SUBJECT: ISSUANCE OF AMENDMENT NO. 9 TO FACILITY OPERATING LICENSE NO. NPF-74 FOR THE PALO VERDE NUCLEAR GENERATING STATION, UNIT 3 (TAC NO. 67865)

PALO VERDE NUCLEAR GENERATING STATION, UNIT NO. 3

Amendment No. 9
License No. NPF-74

SAFETY EVALUATION BY THE OFFICE OF NUCLEAR REACTOR REGULATION
RELATED TO AMENDMENT NO. 9 TO FACILITY OPERATING LICENSE NO. NPF-74,
ARIZONA PUBLIC SERVICE COMPANY, ET. AL.
PALO VERDE NUCLEAR GENERATING STATION, UNIT NO. 3

FIGURE 3.1-1
ALLOWABLE MTC MODES 1 AND 2
PALO VERDE UNIT 3 CYCLE 1

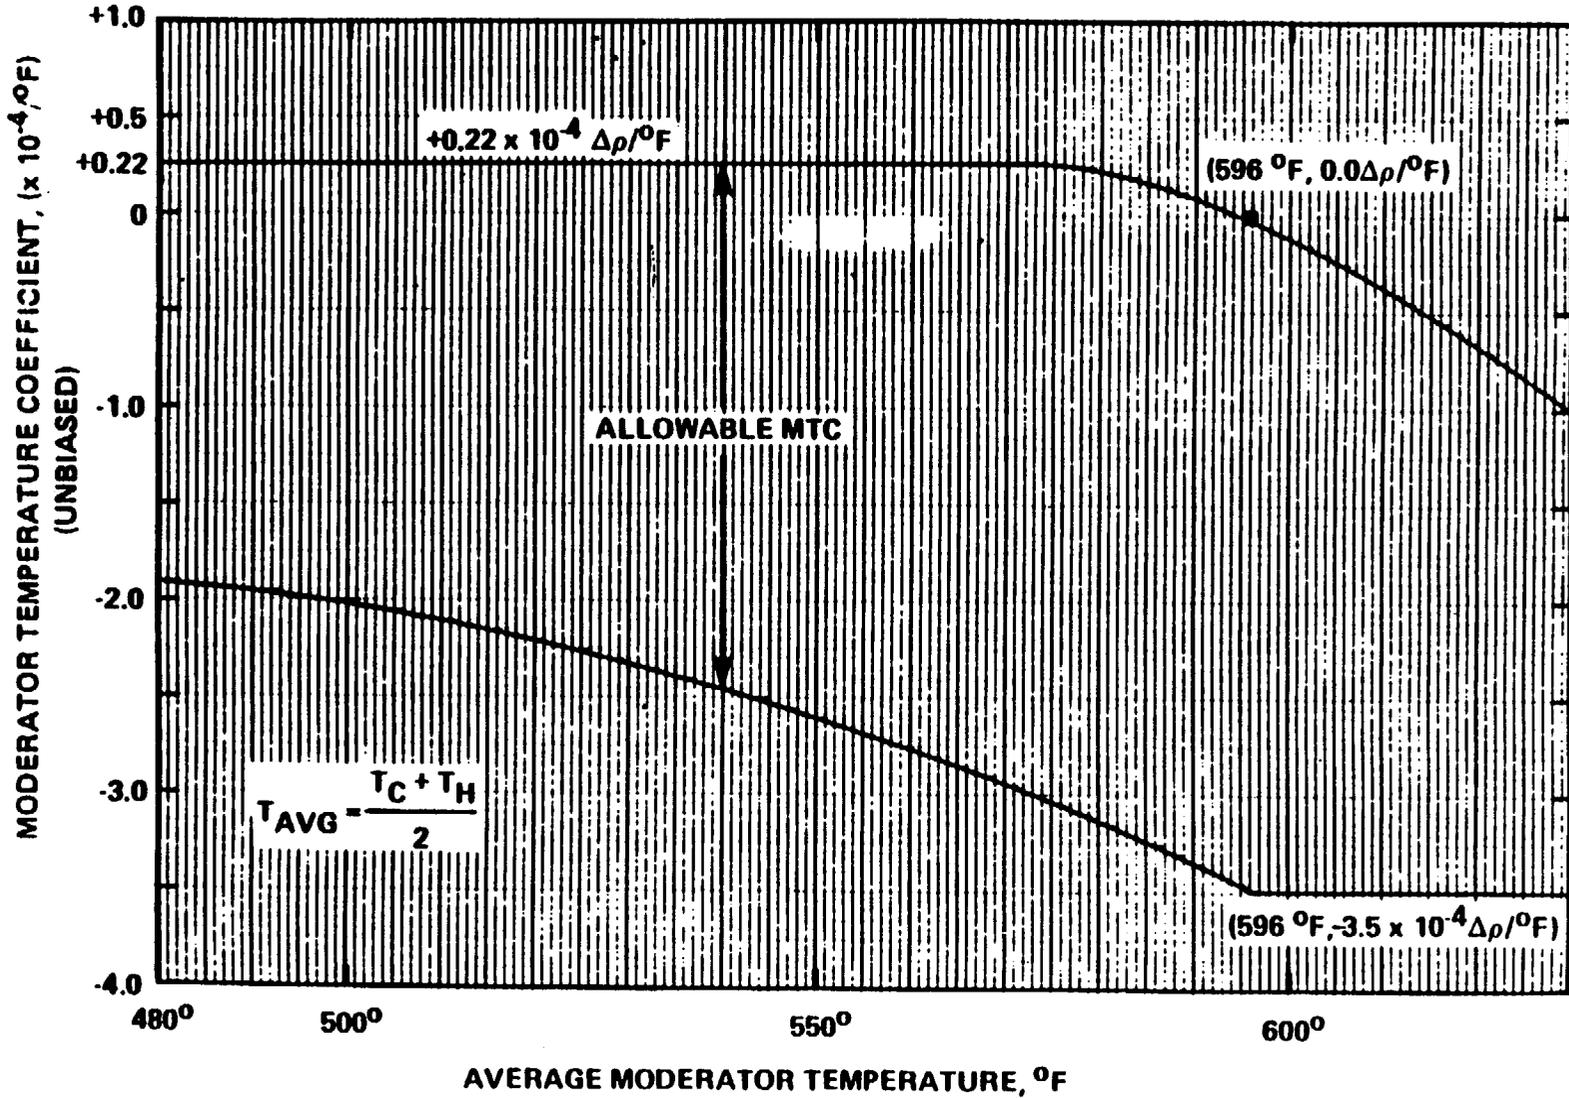
The Amendment revises the Technical Specifications for Palo Verde Unit 3, as follows. Technical Specification 3/4.1.1.3 provides limits on the Moderator Temperature Coefficient (MTC). The Amendment revises Figure 3.1-1 to increase the negative MTC limit from -30 pcm/°F to -35 pcm/°F.

By letter dated April 7, 1988, the Arizona Public Service Company (APS) on behalf of itself, the Salt River Project Agricultural Improvement and Power District, Southern California Edison Company, El Paso Electric Company, Public Service Company of New Mexico, Los Angeles Department of Water and Power and Southern California Public Power Authority (licensees), requested a change to the Technical Specifications for Palo Verde Nuclear Generating Station, Unit 3 (Appendix A to Facility Operating License No. NPF-74). The application requested a change to revise Technical Specification 3/4.1.1.3 by changing Figure 3.1-1 to increase the negative Moderator Temperature Coefficient (MTC) limit from $-30 \text{ pcm}/^{\circ}\text{F}$ to $-35 \text{ pcm}/^{\circ}\text{F}$.

The MTC limit of $-30 \text{ pcm}/^{\circ}\text{F}$ was incorporated in the initial Units 2 and 3 TS under the assumption that the drain line relocation for Units 2 and 3 would occur at the first refueling outage. In reality, the drain line relocation was performed for Units 2 and 3 during initial start-up for each unit. The Unit 2 limit was changed back to $-35 \text{ pcm}/^{\circ}\text{F}$ as part of the Unit 2 Cycle 2 reload TS. This change is necessary to change the Unit 3 TS limit back to the original value assumed in the safety analysis ($-35 \text{ pcm}/^{\circ}\text{F}$).

The current MTC limit of -30 pcm/°F in the Unit 3 TS was required to compensate for the as-built safety injection drain line configuration. Subsequently the drain lines were reconfigured so that the MTC limit of -35 pcm/°F that was assumed in the safety analyses would be valid.

The TS limit on MTC was determined from the CE System 80 steam line break analysis. In the analysis, an assumed moderator reactivity versus coolant temperature function was applied using the most negative (including uncertainties) technical specification moderator temperature coefficient of $-35 \text{ pcm}/^{\circ}\text{F}$ at nominal full power conditions, $T_{\text{avg}} = 594^{\circ}\text{F}$.

The licensees have reevaluated the most limiting transients and accidents which can be adversely affected by the increased MTC operating band and found them to be bounded by the existing Chapter 15 analyses.

Based on the above, the staff concludes that the proposed change to Specification 3/4.1.1.3 is acceptable.
